ADDENDUM No. 1

ITB No. 4419

South Division Street Resurfacing

Due: February 26, 2016, 10:00 A.M.

PROJECT MANAGEMENT - CITY OF ANN ARBOR
S. DIVISION ST. RESURFACING
COVER AND NOTES
STD NOTES
SCALE: N/A
DRAWING No. 2015038-3
SHEET No. 3 OF 41

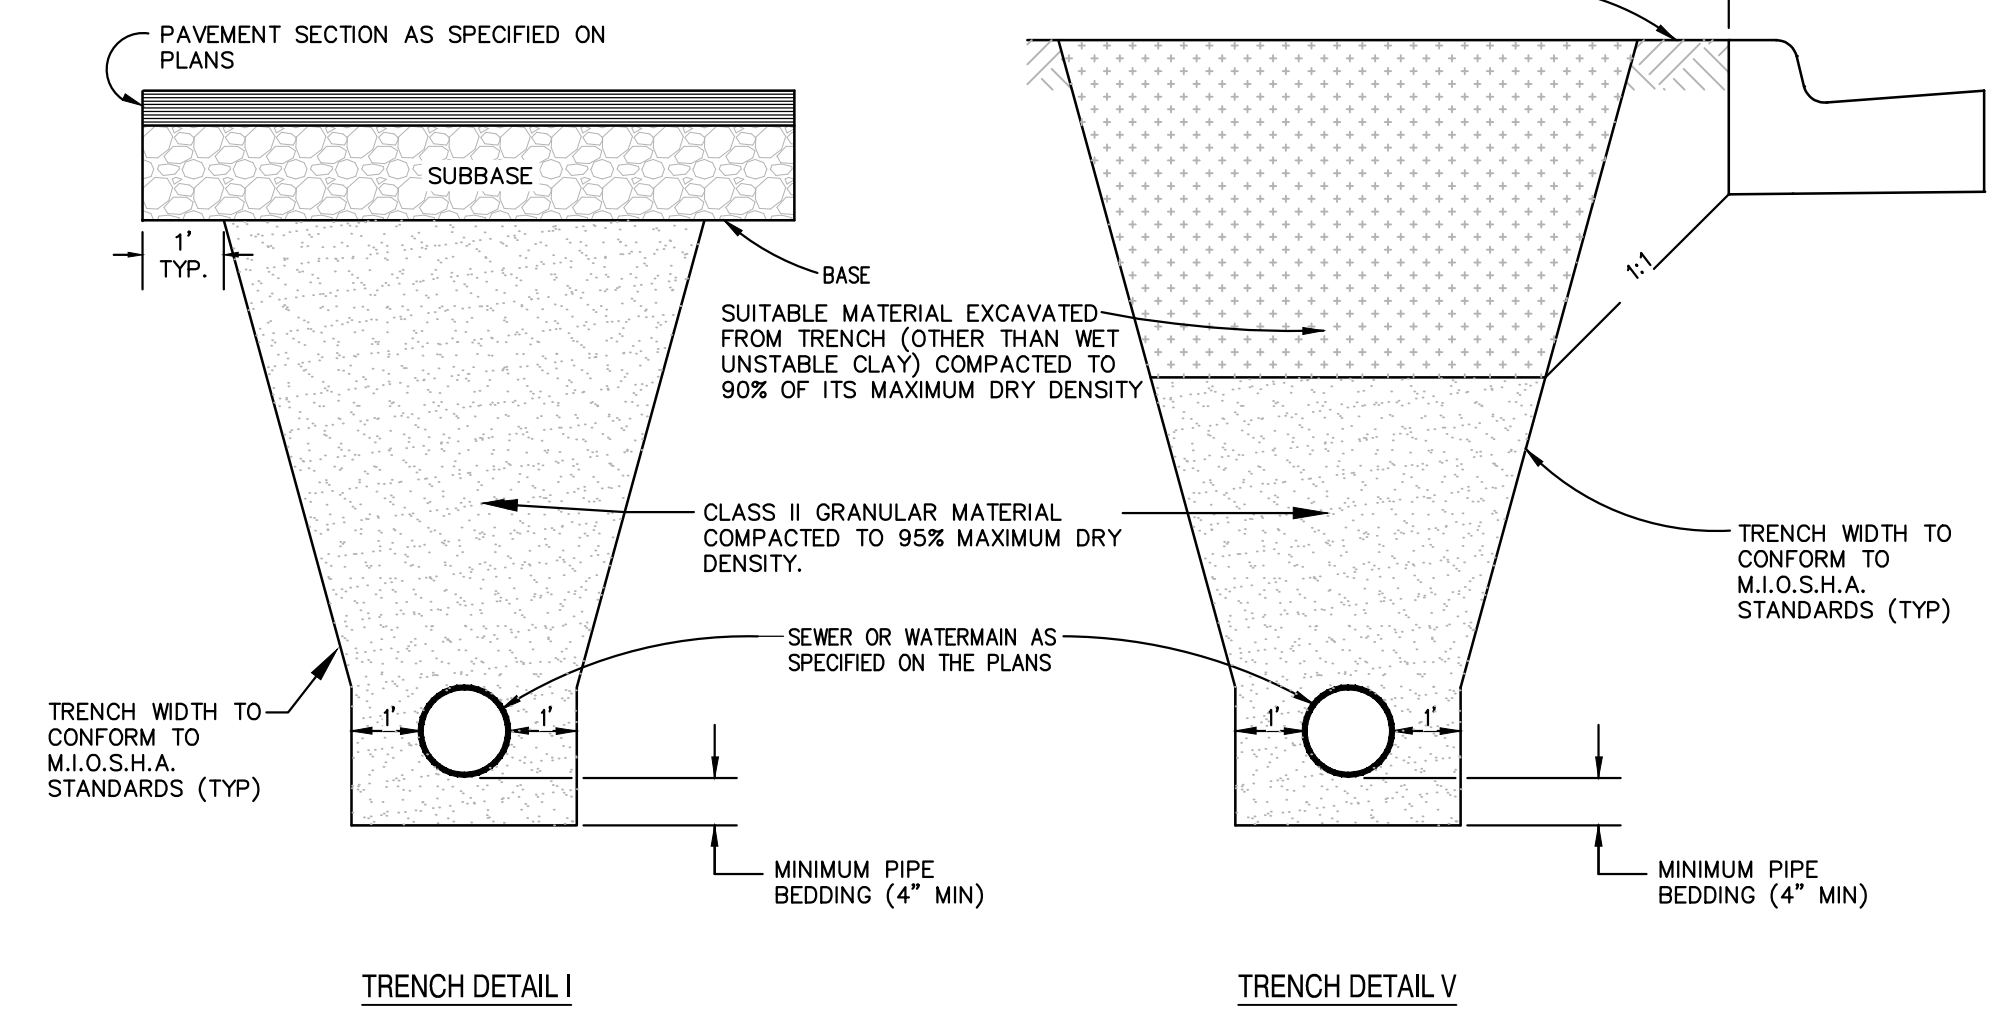
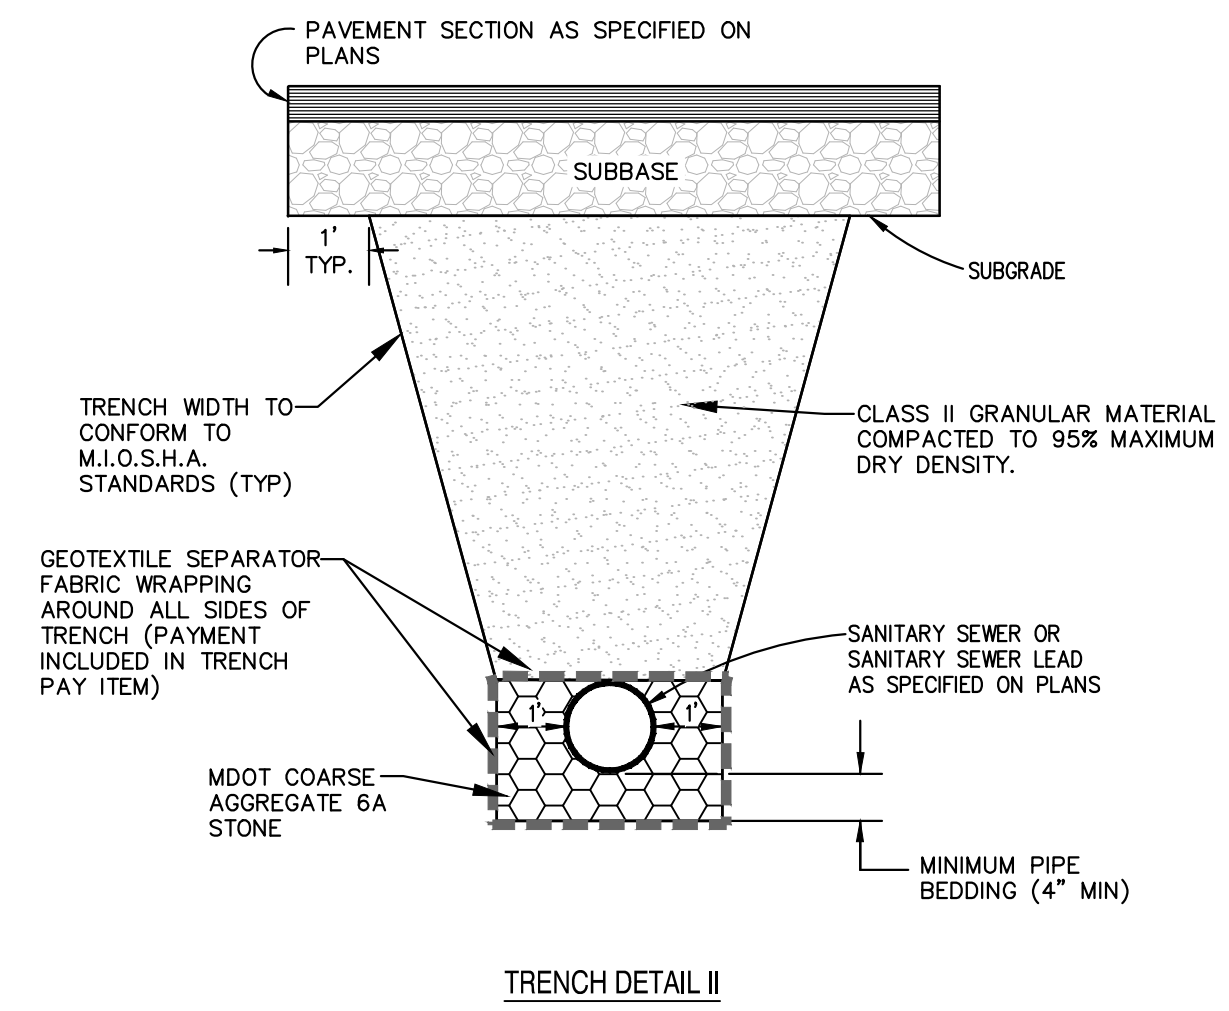
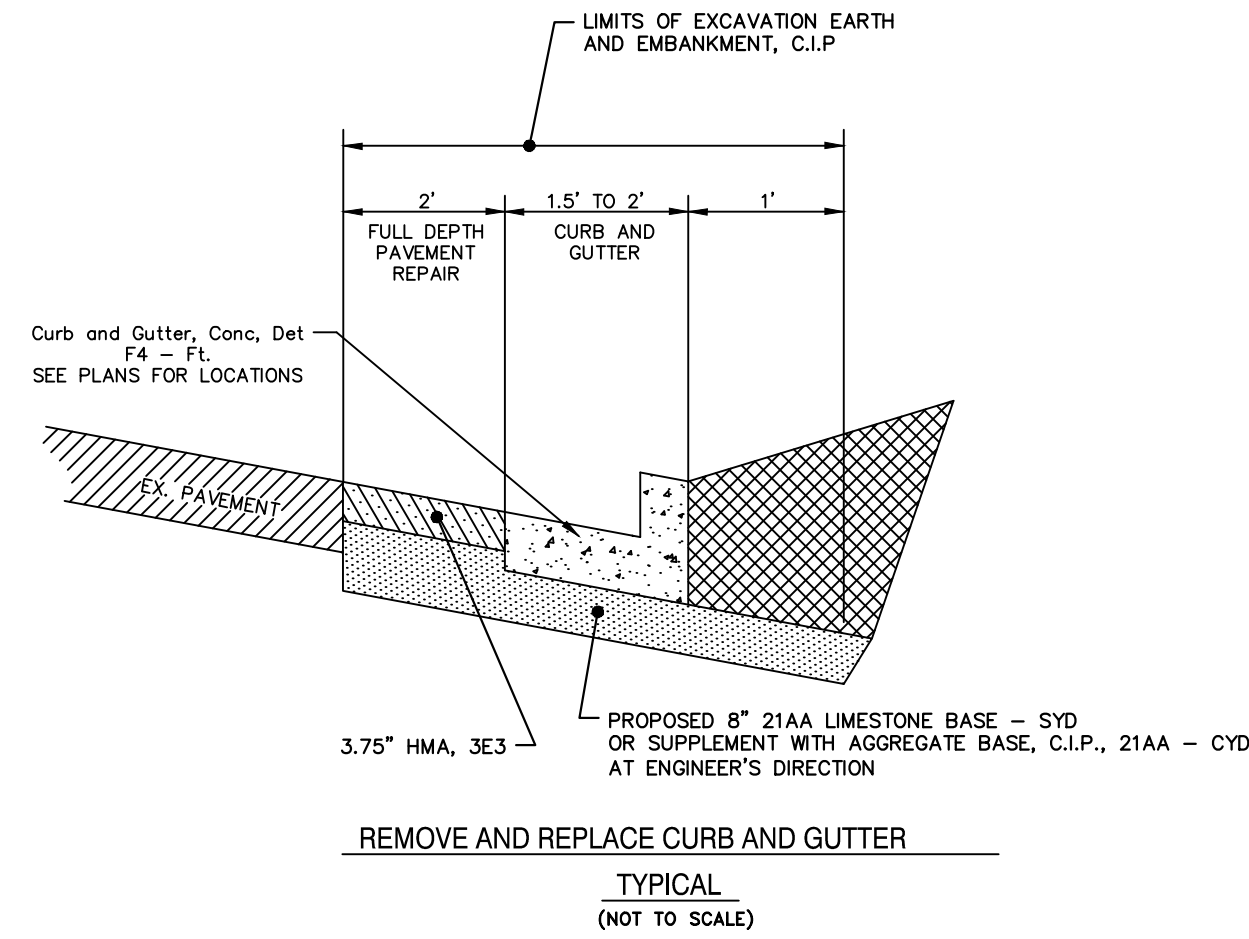
Plans/3.5	Revised and added quantities to reflect changes to bid form.
Plans/5	Revised detail for Remove and Replace Curb and Gutter – revised payment of Roadway Grading to Excavation, Earth and Embankment, CIP.
Plans/9	Added structures to profile view. Revised rims in Water Main Structure Table.
Plans/10	In plan view, corrected abandon limits linework to match notes.
Plans/11	Added valves to profile view. Revised rims in Water Main Structure Table.
Plans/13	Revised removals in William Street intersection.
Plans/15	Revised curb and gutter quantities, added full-depth pavement replacement limits, and corrected shading.
Plans/16, 18 and 19	Added full-depth pavement replacement limits, and corrected shading.
Plans/17	Revised curb and gutter quantities, added full-depth pavement replacement limits and corrected shading, and deleted proposed drainage structure in the northeast quadrant of Williams.
Plans/21	Deleted proposed drainage structure in the northeast quadrant of Williams.

SCALE PLAN: 1" = 20'
DRAWING No. 2015038-28

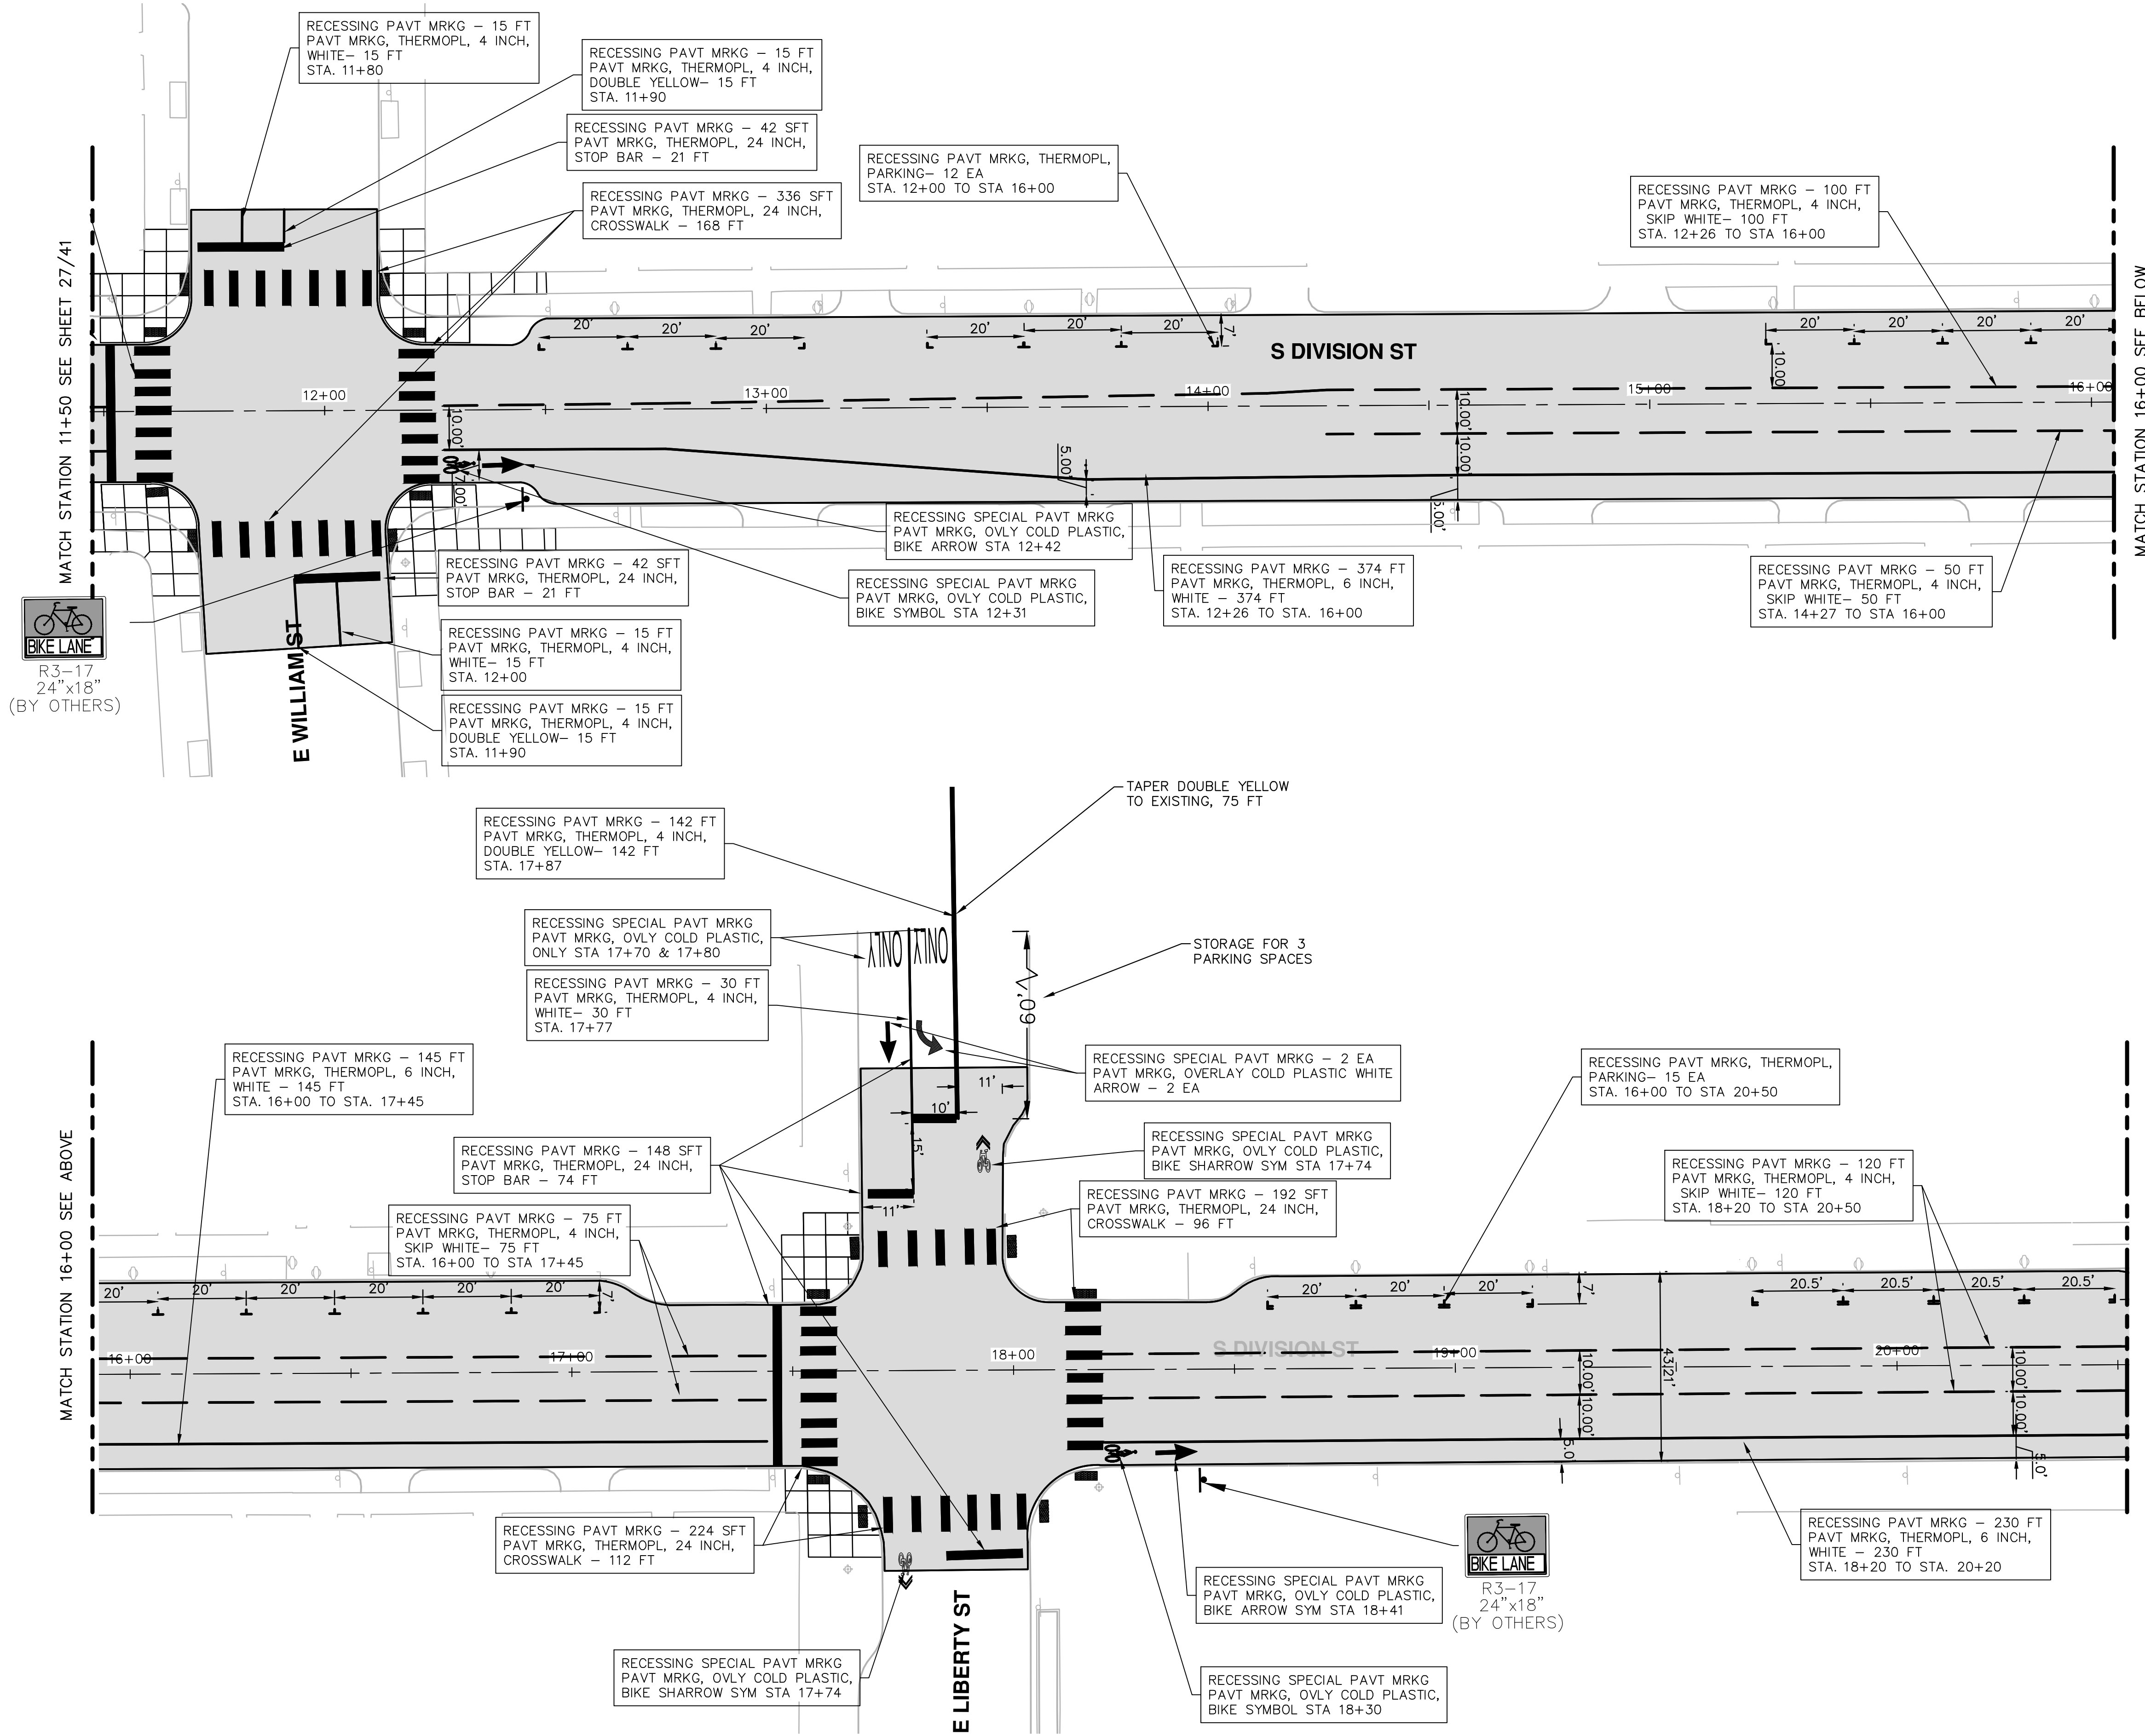
Plans/28	Added pavement marking layout dimensions on the west leg of Liberty.
Plans/29	Corrected parking space markings.
